347-349 CUMBERLAND AVENUE

# APPLICATION FOR PERMIT

Subject: Application for building permit to cover alterations in and change of use of the dwelling house at 349 Cumberland Avenue.

3490. lumber and Cleve  
GROUND FLOOR

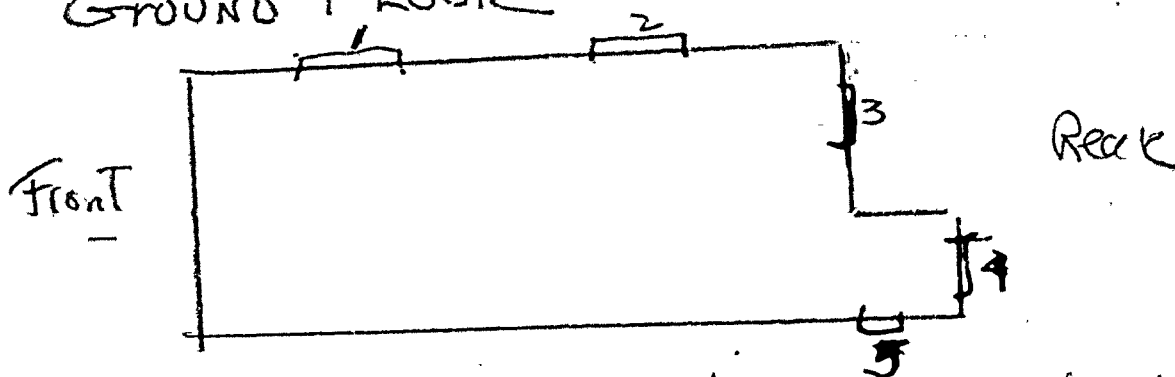
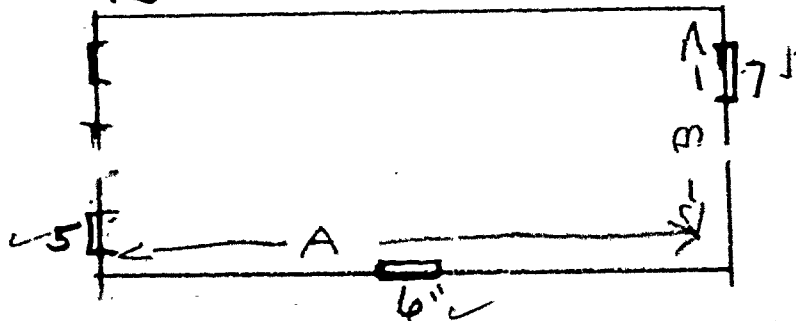
Windows 1-2-3-4 to be closed up  
solid and clap boarded on outside

Windows 5-6-7 to be closed up solid and  
boarded on outside

WALL A and wall B to be covered  
with  $\frac{1}{8}$ " steel plate

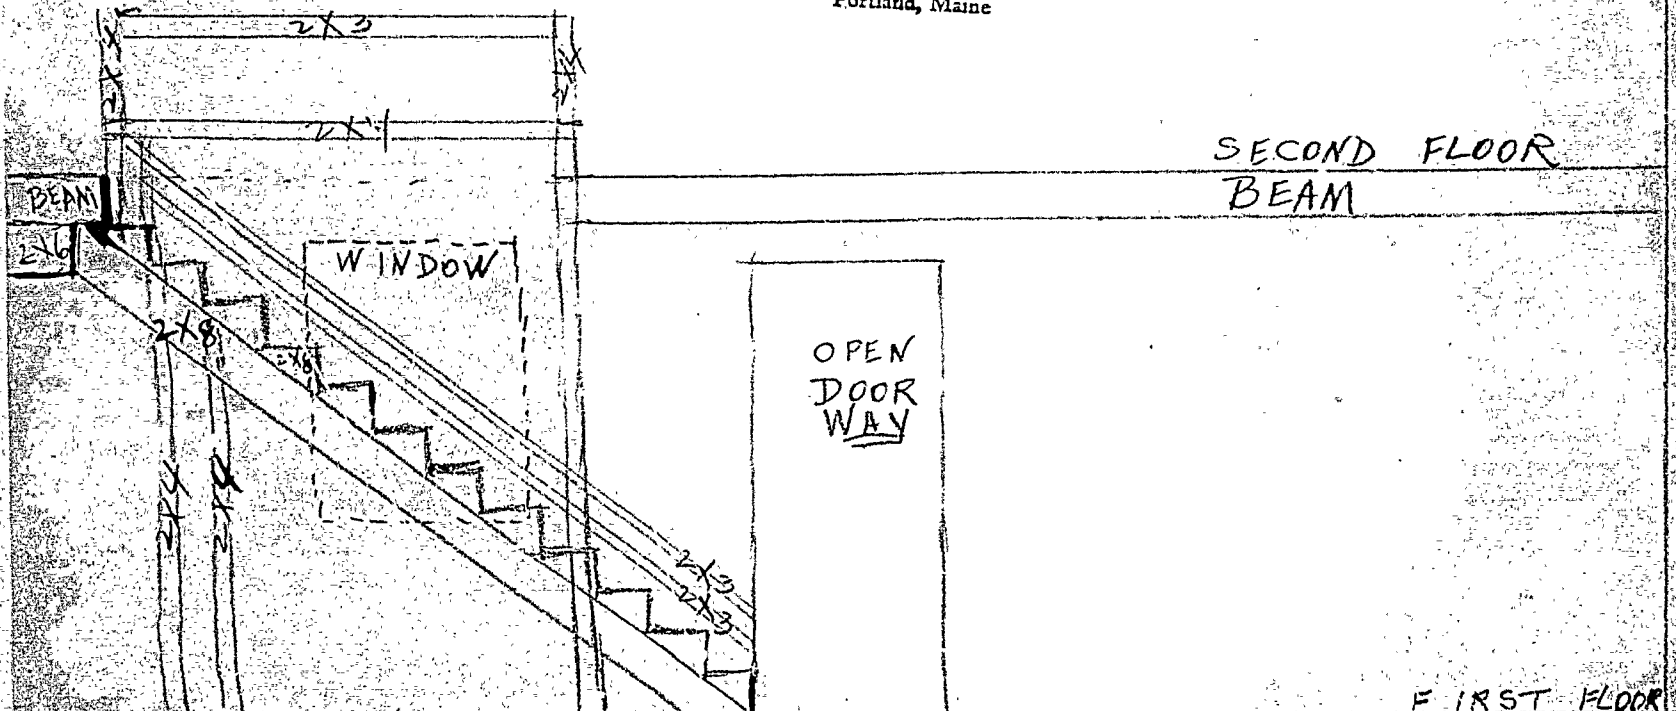
Examination of application for permit for alterations to the building at the above location so as to change the use of both stories from retail business and storage use to manufacturing discloses insufficient information to show that proposed work will comply with Building Code requirements. The following additional information is needed before application of the Code to the proposition can be determined:

- is manufacturing to be carried on in both first and second stories of the building? — *Both*
- are any new partitions to be erected in either story? — *None*
- is space where sales to be made to be partitioned off from manufacturing area? — *None*
- floor plan of second story is needed to show location of new stairway in relation to the front stairs and of first story to indicate location of bottom of new stairs as regards the rear exit door. — *Provided*
- indication is needed as to width of stairway, size of landings at top and bottom of stairs, and that pitch of stairs is to be such that height of risers will not exceed 8½ inches and width of treads will be not less than 9 inches, these measurements to be taken on the stair points and not including any nosing of treads. *7*

Permit for the proposed work cannot be issued until information has been furnished indicating compliance with Building Code requirements.

CONDITION AT A.A. REMOJIS

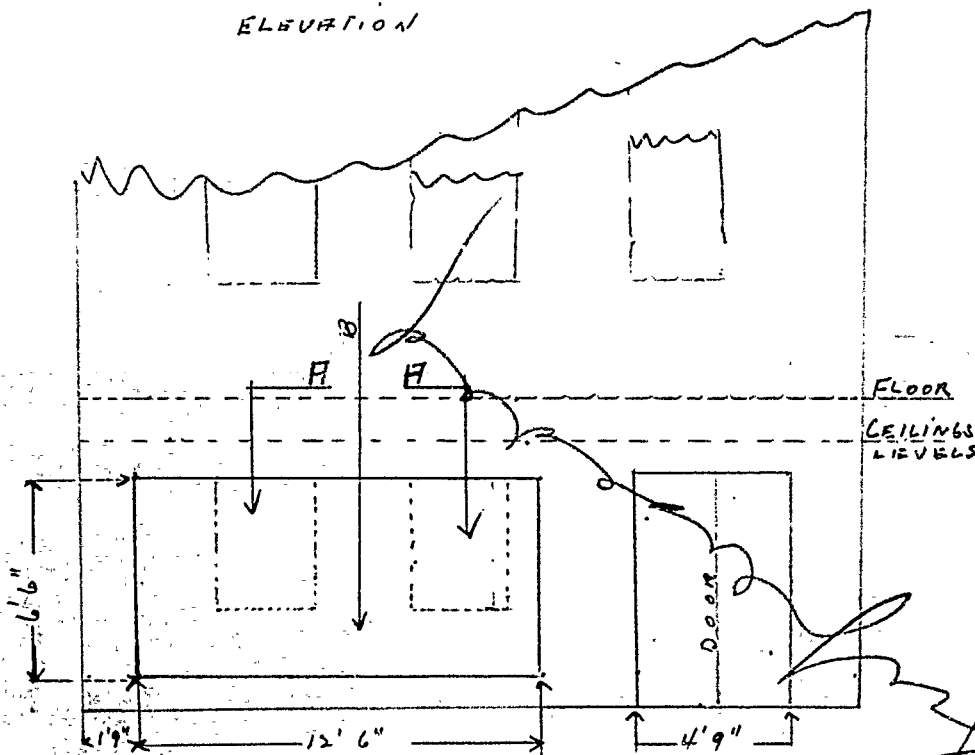
B. INSTALL TRIPLI THICK PLATE GLASS
